# UNITED STATES PATENT AND TRADEMARK OFFICE

APPLICATION NO.	FILING DATE	FIRST NAMED INVENTOR	ATTORNEY DOCKET NO.	CONFIRMATION NO.
10/766,136	01/27/2004	Walter J. Leclair	WLD-002	1966

<b>Office Action Summary</b>	<b>Application No.</b> 10/766,136	<b>Applicant(s)</b> LECLAIR, WALTER J.	
	<b>Examiner</b> Mary Hoffman	<b>Art Unit</b> 3733

## **DETAILED ACTION**

**Fig. 9E**

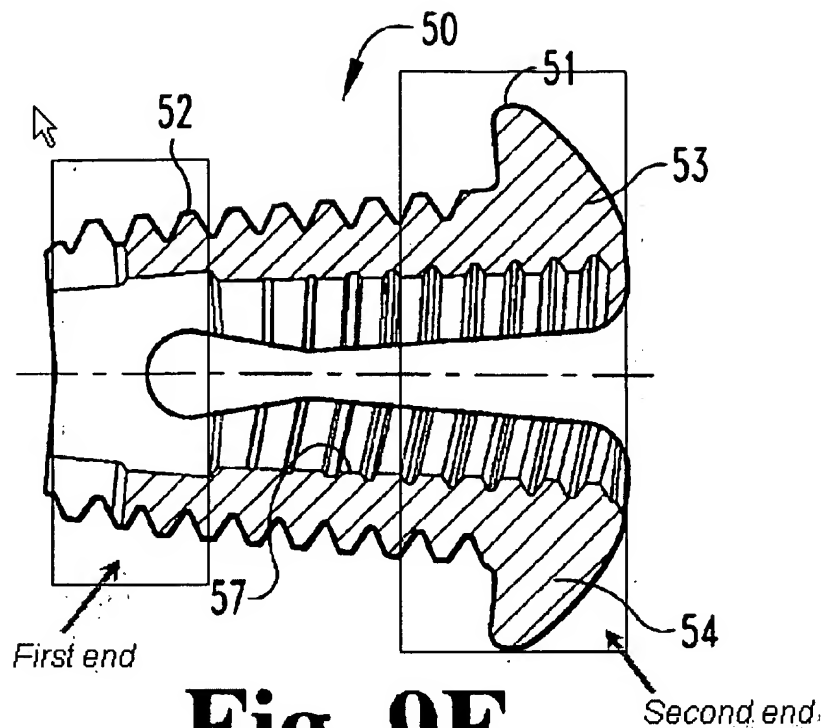
Drewry et al. disclose a bone fastener having a shaft having a first end and a second end (FIG. 9E). A screw thread extending from the second end circumnavigates the shaft (ref. #52). A plurality of elongate slots is formed longitudinally in the shaft from the second end, creating a plurality of furcated branches. The plurality of branches bend outwardly from a first screw diameter to a relatively larger second circumferential diameter. The plurality of furcated branches can compress to the first screw diameter state when the fastener is initially positioned at the opening of a hole. The plurality of furcated branches return to the second circumferential diameter upon reduction of a radially compressive force. The plurality of furcated branches extends for a distance of at least half of the length of the shaft. The screw thread extends from the second end of the shaft at least substantially to the first end of the shaft. A screw head is disposed at the first end of the shaft. The fastener comprises a driver recess disposed at the first end of the shaft (see hole in screw head). The plurality of furcated branches has sufficient flexibility. The fastener is formed from titanium.

Applicant's arguments that the Drewry reference does not disclose "a screw thread extending from the second end...slots longitudinally formed in the shaft from the second end and creating a plurality of furcated branches", the examiner disagrees. After consultation with S.P.E. Examiner Robert, it was determined that the limitation "extending from the second end" is not specific enough to distinguish the invention of the application from the Drewry et al. reference. See the marked-up figure (next page) to illustrate this point.

A suggestion to aid in overcoming the Drewry et al. reference is to specify that there is an enlarged screw head is at the first end and the slots are located at the second end.
